Request for Additional Information No. 437(4953), Revision 1

U. S. EPR Standard Design Certification

SRP Section: 06.02.01 - Containment Functional Design

Question 06.02.01-99:**Follow-up to RAI 221, Question 06.02.01-23**

Figure 06.02.01-99-1—Room UJA07026 Vent Paths

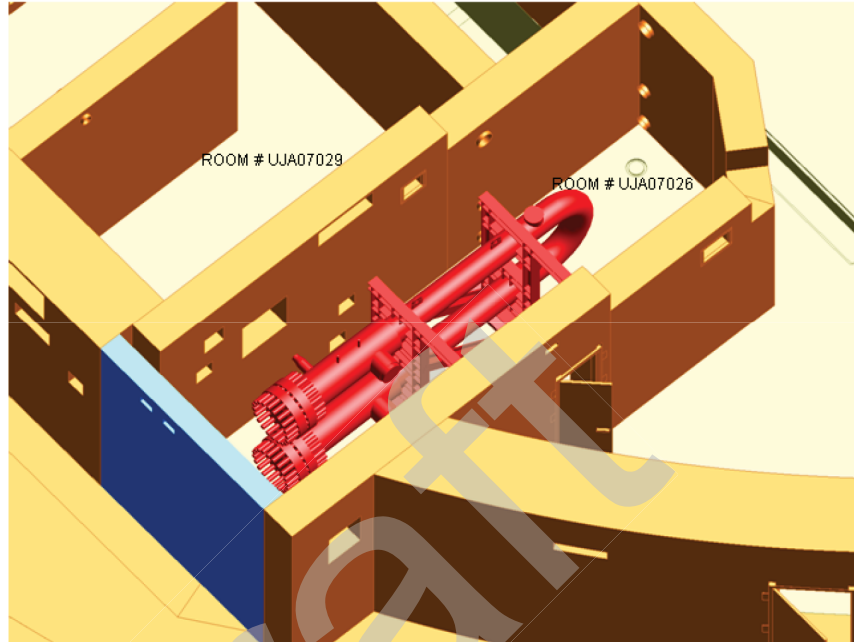
- a. Provide justification that the vents, drains and penetration openings connecting each of these compartments to the bulk containment are adequate to sufficiently equalize before the peak containment pressure is reached for design basis accidents.
- b. The "Net Room Volumes" provided in Table 06.02.01-23-1 differs from the values for the compartments provided to the staff in the response to RAI 40. Provide a comparison between the volumes in the two responses. Identify which values are correct and discuss the reasons for which different values were given.

- a) Most of the isolated compartments are valve rooms or contain equipment such as heat exchangers. Eight of these compartments (UJA07021, UJA07026, UJA07027, UJA07028, UJA07029, UJA11022, UJA11023, and UJA11024) are lumped together in GOTHIC control volume number 17. These eight compartments are valve rooms or contain heat exchangers, and each compartment contains pipe penetrations providing vent paths to the surrounding areas. Figure 06.02.01-99-1, Figure 06.02.01-99-2, and Figure 06.02.01-99-3 show numerous vent paths connecting these rooms, and this verifies that these compartments will pressurize.
